PHASE III PUBLIC INPUT SUMMARY

OCTOBER 28-29, 2015

The City of Raleigh along with their consultants, Lord Aeck Sargent hosted their last public workshops on October 28 and October 29, 2015. Both workshops presented final recommendations for zoning, transportation, and public realm improvements. Four planning stations were provided to encourage attendees to explore the Cameron Village and Hillsborough Street Small Area Plans recommendations in further detail: Land Use and Zoning, Public Realm Network Traffic and Parking Strategies, and Advisory Committee. The goal of the workshops were to inform and gain consensus with the public regarding the draft recommendations.

Gorman Street - After

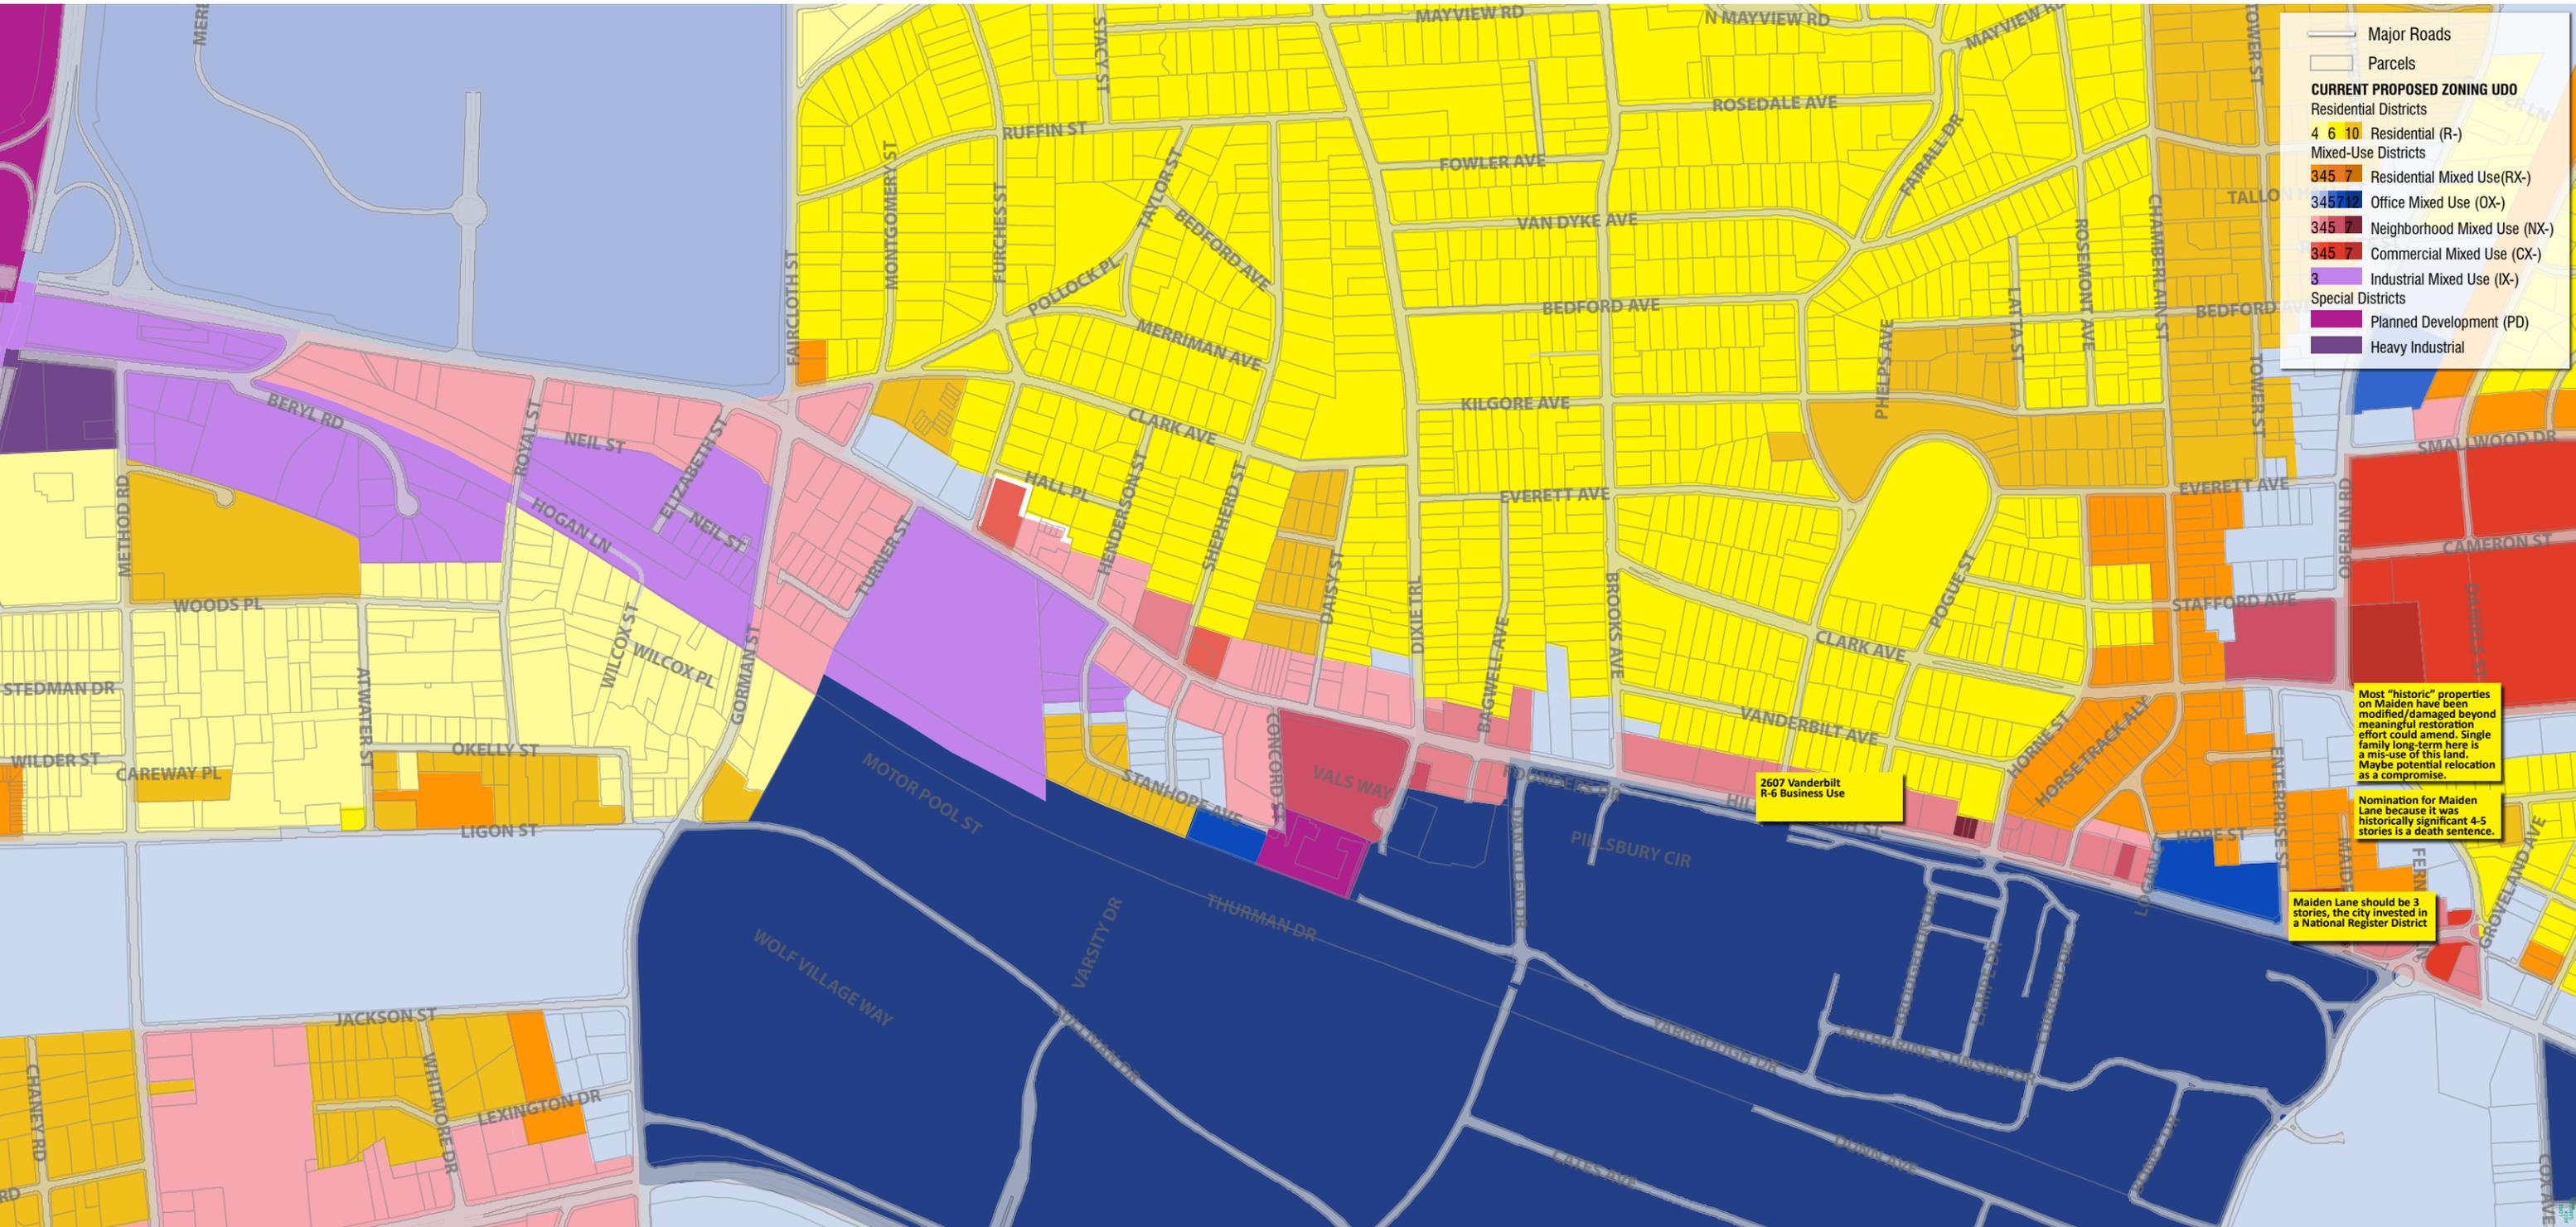
Like the idea of a large round-about with large planting & central sculpture feature

Also, like having low planting in median as you leave round-about

A lot more study on round-about here Lots of traffic going to light at Wade

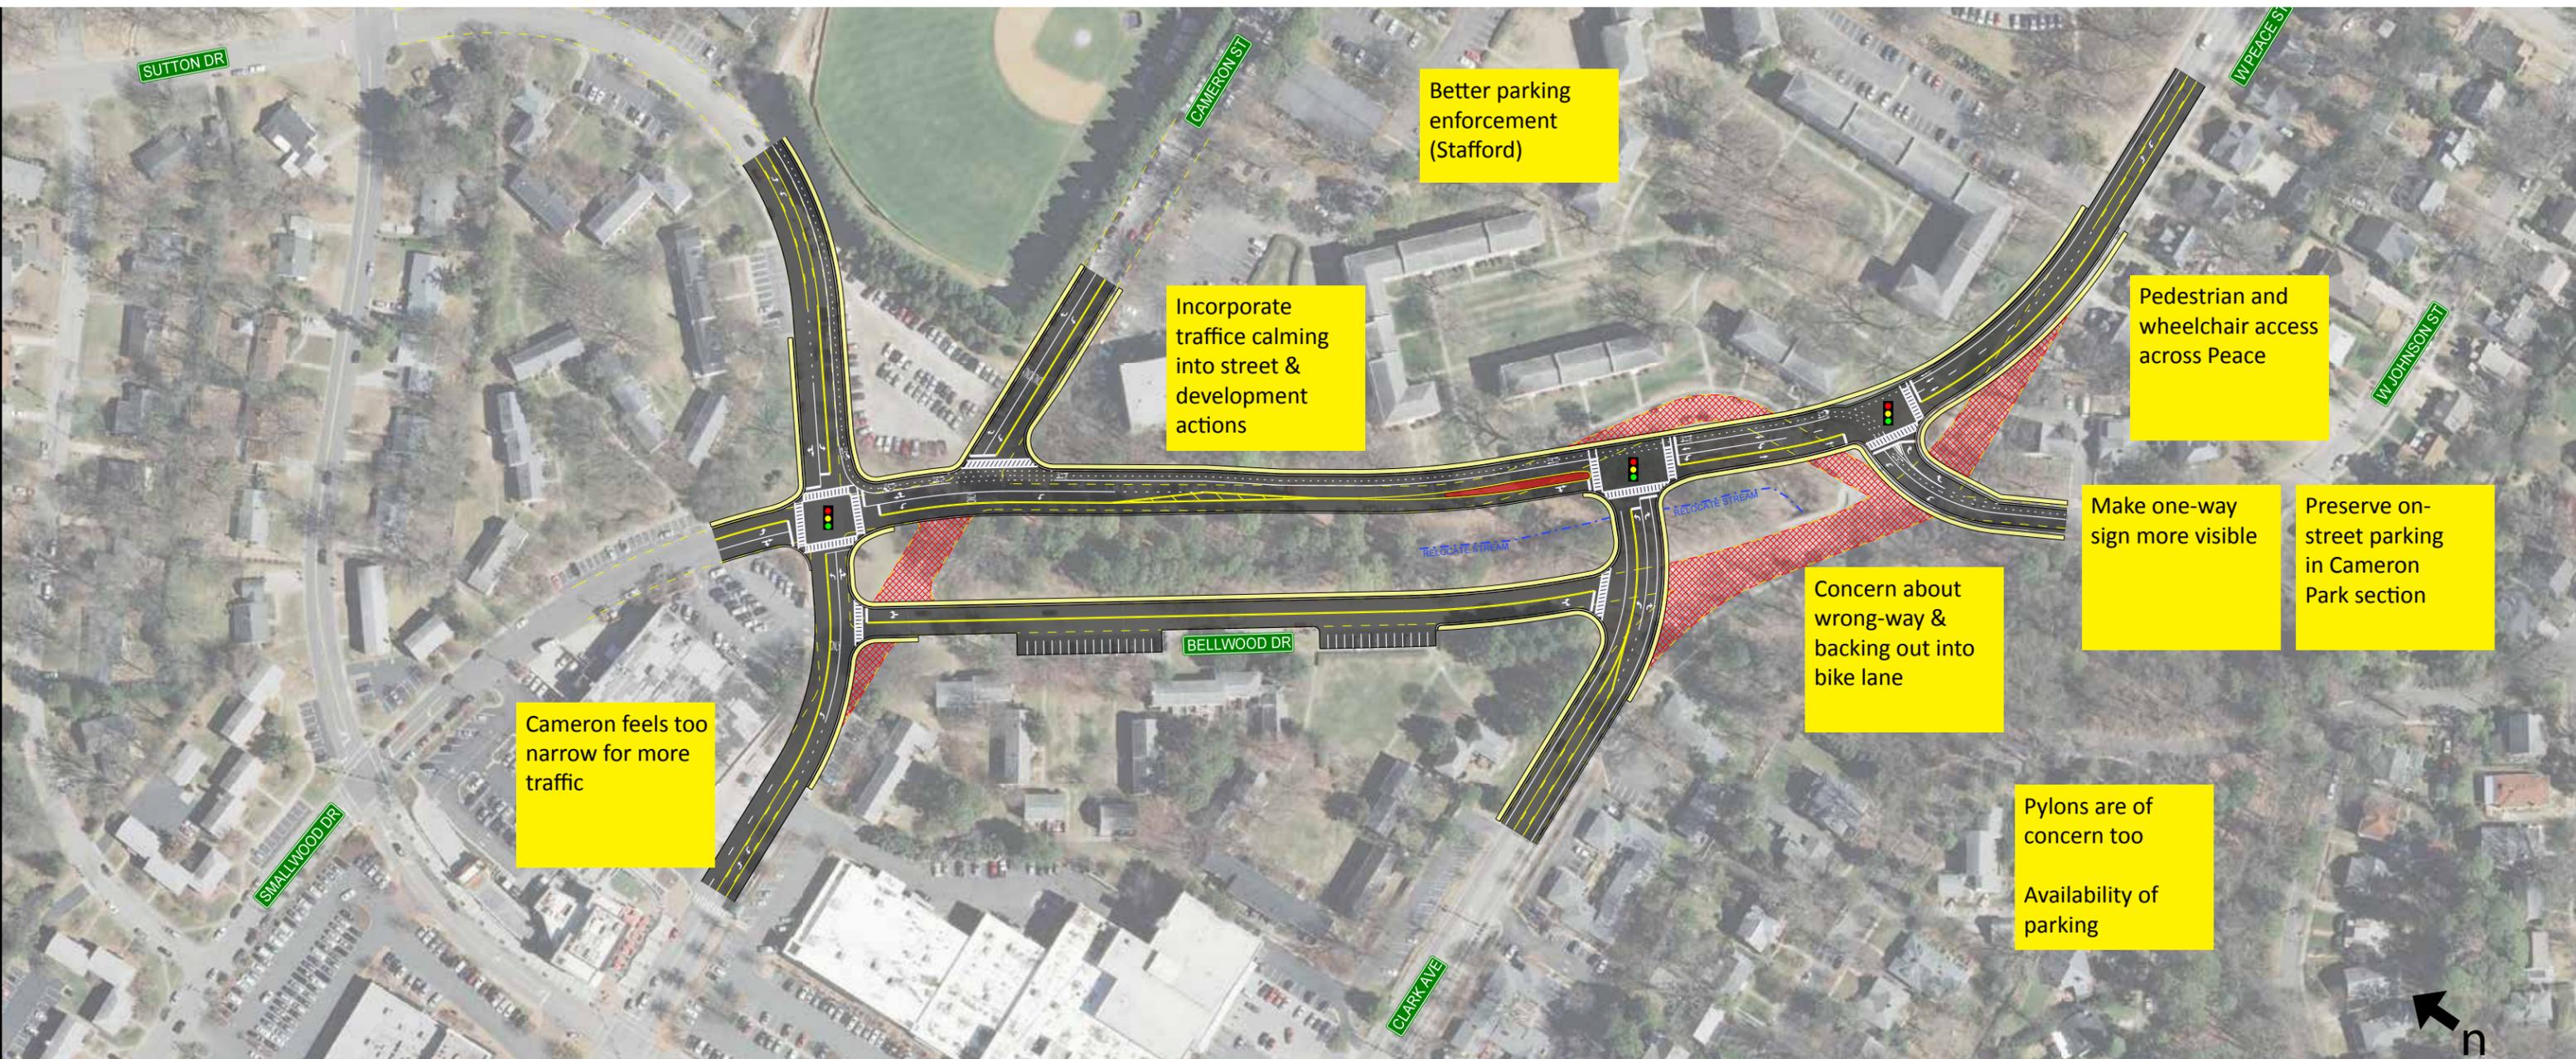
This is awful. Please don't allow this level of intensity on Hillsborough, Oberlin or Clark. 3-4 stories is about right.

Please encourage setback/articulation of facade (1'-2' min) flat elevations to the street are not good

All the buildings look the same. So sad

Commend the idea of mixed heights

District 1 - Land Use & Height Recommendations

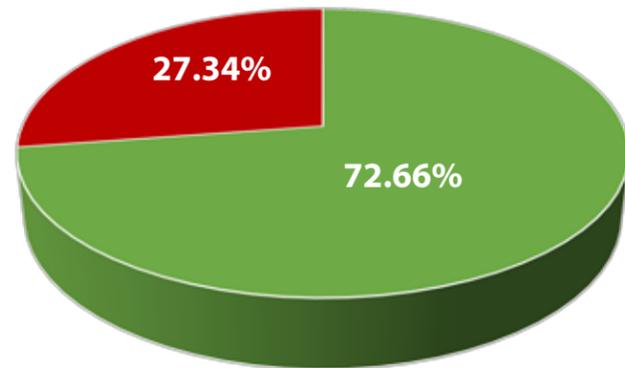
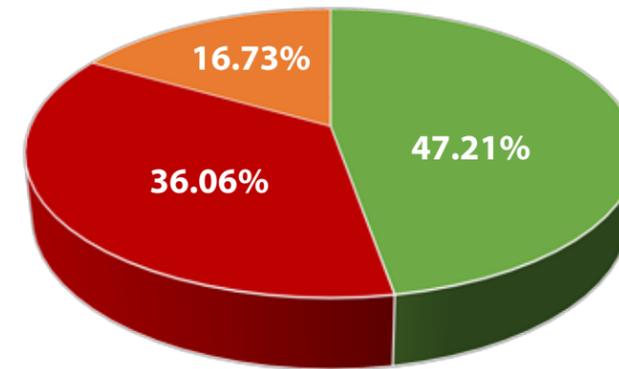
- Heights of businesses and apartment buildings are intruding into single-family neighborhoods
- Limit the amount of office
- Oberlin Road is overburdened already

- Provide open space within new development
- Appropriate height along Oberlin Road

- Don't lose the character and charm of the area.
- Need for traffic relief on Oberlin Road.
- The plan must address parking issues.
- New development must take stormwater issues into consideration.
- Consider how bicycle lanes may impact existing neighborhoods, both pros and cons.
- Additional pedestrian/bicycle connections from Daniels to Oberlin would be good, vehicular connections would need further study.

District 2 - Land Use & Height Recommendations

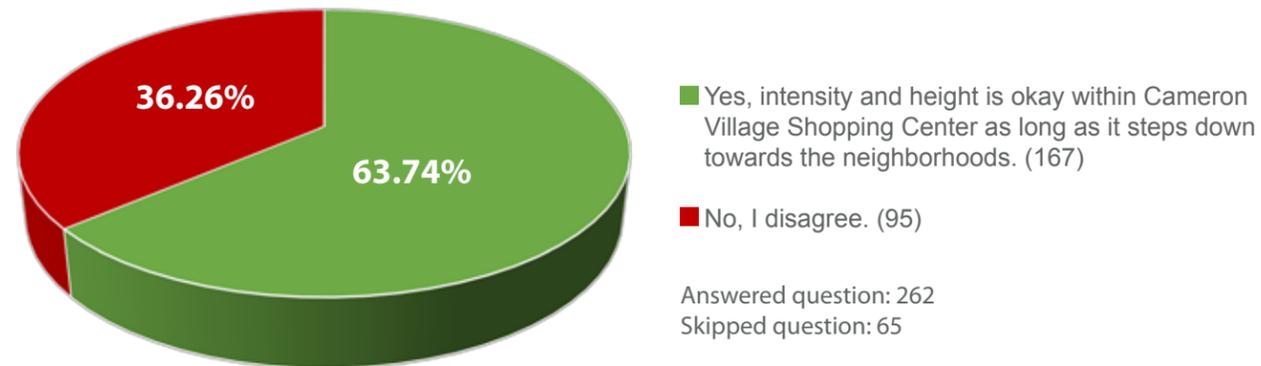
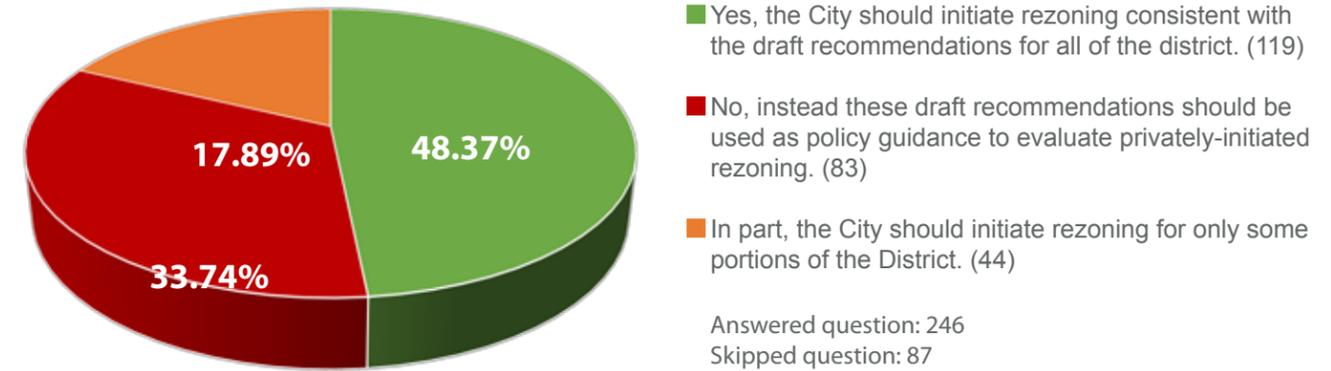
- * Additional comments from the public centered around the topics of:
- Do not compromise the historic fabric of the area.
 - Address parking issues before considering future development.
 - Appropriately transition heights down towards neighborhoods.

- Contain density to Oberlin Road and Hillsborough Street.
- The height of the new buildings in Cameron Village should not 'bleed' into the residential areas.
- Remove the potential for bars on Clark Avenue.

- Don't sterilize or generalize the area just to match sprawl.
- Create nodes of commercial development.
- Clear up the Oberlin / Clark intersection.

District 3 - Land Use & Height Recommendations

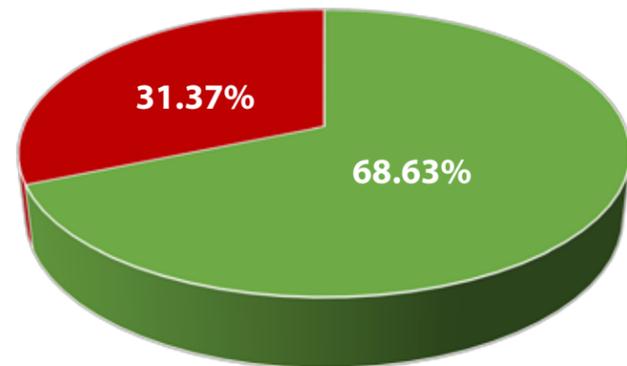
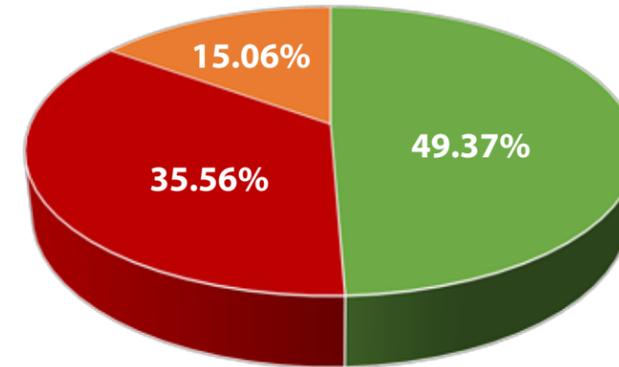
- Protect Pullen Park and its surrounding neighborhood the same as Cameron Park and Cameron Village.
- Address the need for transportation before development can be considered.
- Height, both in favor of additional height, or a desire to keep new building heights at the same level as existing buildings, are a major concern.

- The commercial and office zoning along Hillsborough St is fine, but there really should not be more residential development.
- Rezone all areas per the density suggestions above. The uses are fine as suggested.
- Both the south and north portions of this zone should be treated the same with opportunities for increased density.

- Concerned about encroachment of height and density into Cameron Park. Don't think there should be as much R-10 in the neighborhood (Calvin, Hillcrest and Johnson). R-4 or R-6 is more appropriate.

- The Pullen Park Neighborhood should have consistent zoning throughout - either all R-10 or all RX with 5 height limitation on Cox Avenue, Park Avenue, Ashe Avenue, Dexter Place and Flint Street.

- This plan should give the same protections to University Park and keep maximum heights low around University Park, the north side of Hillsborough St and west side of Oberlin. The intensity and height should be increased along the south side of Hillsborough St and the east side of Oberlin.

- OX-3 around Cameron Park needs to be well thought out, especially as it relates to transitions to residential. Most of the surrounding offices are converted historic structures that don't fill the entire lot and fit in with the neighborhood well. There is potential for development on the surface lots at the corner of Hillcrest and Hillsborough Street that concerns me.

- Would prefer to see RX zoning applied consistently across current residential areas, rather than adopted later through individual site rezonings.

District 4 - Land Use & Height Recommendations

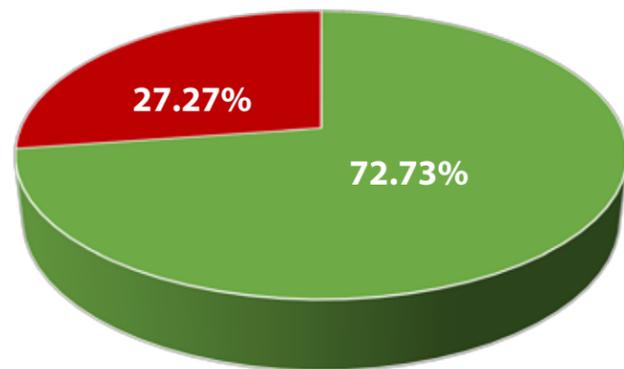
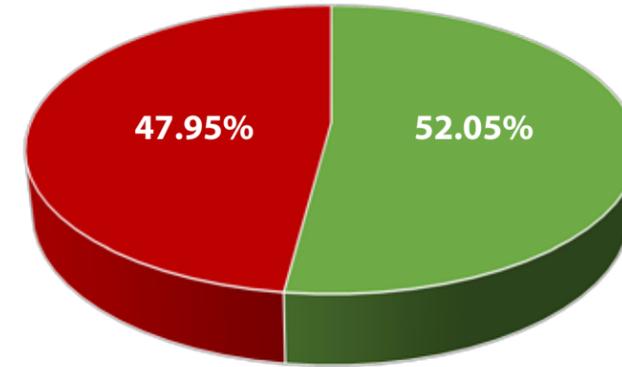
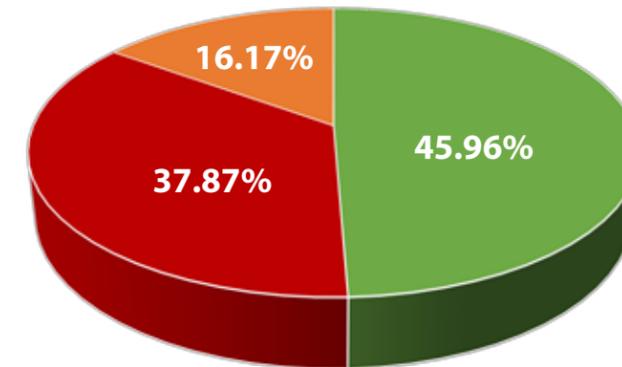
- Clark should be expanded as a large boulevard with wide sidewalks. Adjacent property should be higher intensity. Minimum 7 stories. There are already several buildings that are greater than 75 feet. Hillsborough is wide enough to avoid creating any "canyons" effect.
- I do not agree with 3 story residential mixed-use encroaching on purely residential neighborhoods - specifically those bordering Stafford, Horne and Everett
- Allow Hillsborough and Cameron Village to develop as separate and unique entities. Parcels of historic neighborhoods between these development areas can serve both areas well to avoid becoming a commercial cliché.

- Vanderbilt is an important, historical buffer serving the University Park neighborhood in keeping its residential character from being eroded by Hillsborough Street. Vanderbilt should not be rezoned but should remain R6 -- low density residential zoning.
- It should be residential zoning. These are areas where NC State students should be able to call home and live. The location is perfect for students. Move office zoning further off from the campus area
- This areas serves as an important buffer between Hillsborough Street and the other neighborhoods. It should be protected as residential.
- I think it's important to keep the residential character of the University Park neighborhood when adding offices.

District 5 - Land Use & Height Recommendations

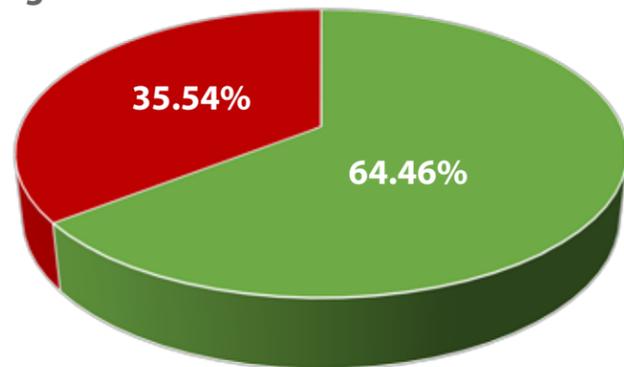
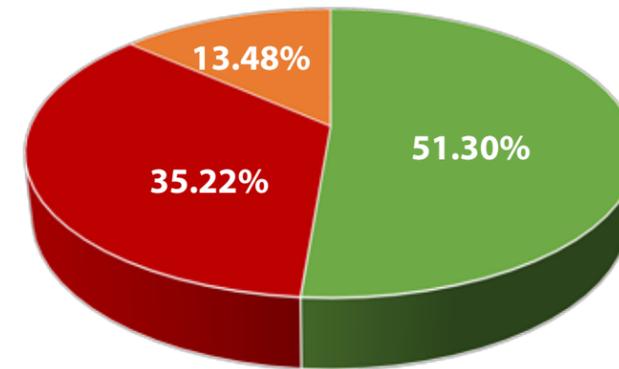
- 5 stories is more appropriate. New investment should be encouraged.
- Support the commercial investment, but use a step down height restriction to 2-3 stories against the R-6 residential. Higher than 4 stories for areas buffered away from residential.
- There is a long-established neighborhood that is well-kept and growing adjacent to Hillsborough Street (from Shepherd to Montgomery Street). To retain the character and family orientation, three stories should be the maximum height allowable. Some new commercial development, oriented not just to students, would be reasonable on the south side, but no more than three stories on the north side (residential or commercial development). This would provide a variety of heights along this section of Hillsborough, and help to avoid a canyon effect.

- The city should initiate rezoning consistent with the draft recommendations shown on the map only in the areas directly on Hillsborough Street; in addition, building without appropriate parking should not be allowed.
- I worry that rezoning the entire Hillsborough corridor will lead to terribly designed developer buildings similar to those located at the corner of Clark and Oberlin, and the high density building on Hillsborough and Concord.
- This is an area with tremendous potential for appropriate development/redevelopment. All non-residential properties within the district should be rezoned to 5+ stories. Properties along the transit corridor of Hillsborough Street should not be limited to 3 or 4 stories.

- Varying the heights of development will help vary the experience along that street. I think higher density development at Hillsborough and Faircloth makes a lot of sense, but I'd consider maintaining the area between Furches and Dixie Trail. Consider increasing the density on one side of Hillsborough Street, but allowing relief on the other. Inserting a park along the way would also be welcomed.
- Variety other than student focused apartments is important, especially with adjacency to established neighborhood.
- I think this end of Hillsborough could support retail/commercial properties on its own without the addition of residential properties. I think a shopping/restaurant "village" would add more to the neighborhood and the proximity to such high volume traffic areas would support this as well.
